SUBSURFACE WASTEWATER DISPOSAL SYSTEM APPLICATION

PROPERTY LOCATION		>> Caution: Permit Required – Attach in Space Below <<
City, Town, or Plantation	Augusta	
Street or Road	895 Young Road	
Subdivision, Lot #

Subject: Approval, Replacement System Variance Request, Marin property, Young Road, Augusta

SUBSURFACE WASTEWATER DISPOSAL & SITE PLAN

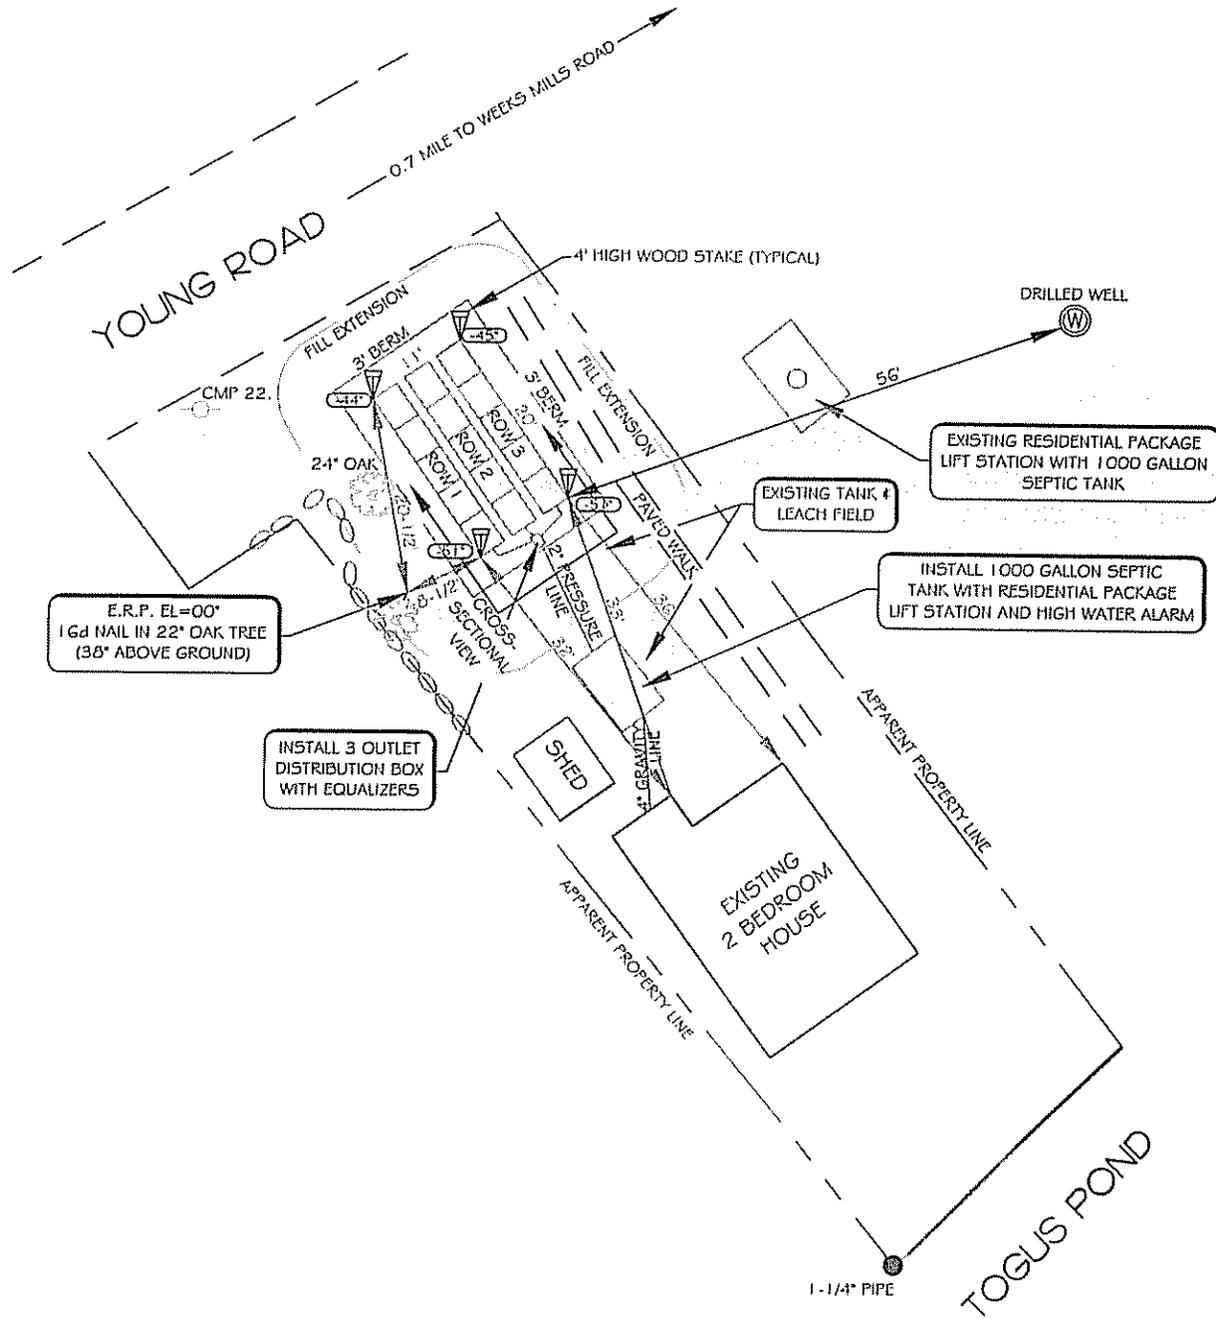
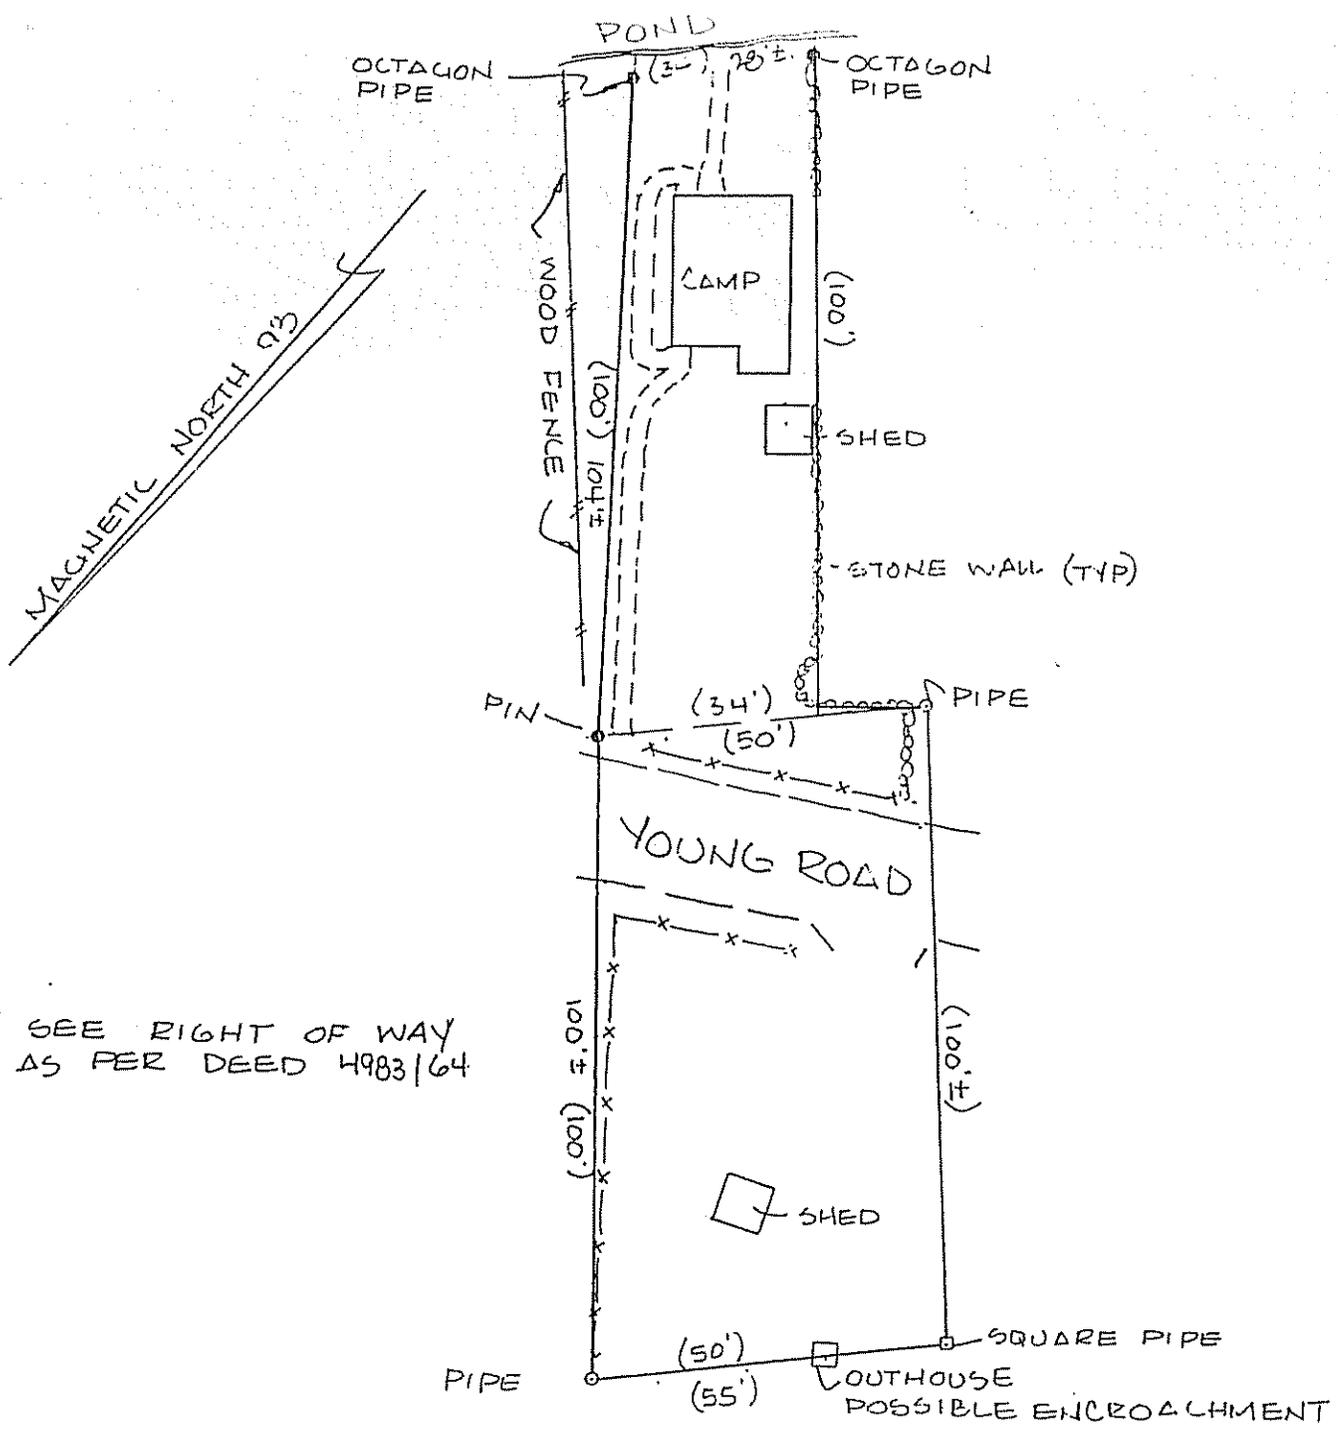
The Division has reviewed a Replacement System Variance Request for the subject property. The state variance requested is to allow the installation of a subsurface wastewater disposal system with a reduction in the setback distance to a neighbor's well from the disposal field to 56 feet. Other variances required are reduced setback distances of 60 feet (septic tank) to a neighbor's well and 82 feet (disposal field), 60 feet (septic tank) to a major watercourse. The system design prepared by Kane Coffin, SE, dated 10-11-00, is found to be in compliance with the Maine Subsurface Wastewater Disposal Rules.

We approve the requested variances with the following requirements:

1. A permit for system installation is to be obtained from the Local Plumbing Inspector in advance of the start of system construction.
2. The system is to be installed in accordance with the submitted and approved system design. Should alterations be required at the time of system installation, the system designer must be notified prior to making any changes.
3. The variance approval is based only on the rules administered by this department. The approval of the variance request does not relieve the property owner from compliance with all other state and local requirements pertaining to the installation, use, and operation of the wastewater disposal system.
